### Observation in relation to Planning Application F17A/0392 at Holywell

### **Observation in relation to Planning Application F17A/0393 at Holywell**

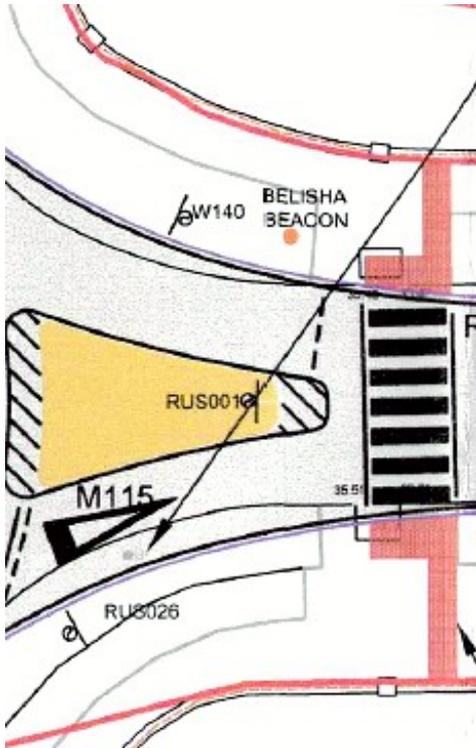
Is this element of the design (excerpt below) a one-way cyclepath or a two-way cyclepath? The road markings seem to show cyclists yielding in both directions.
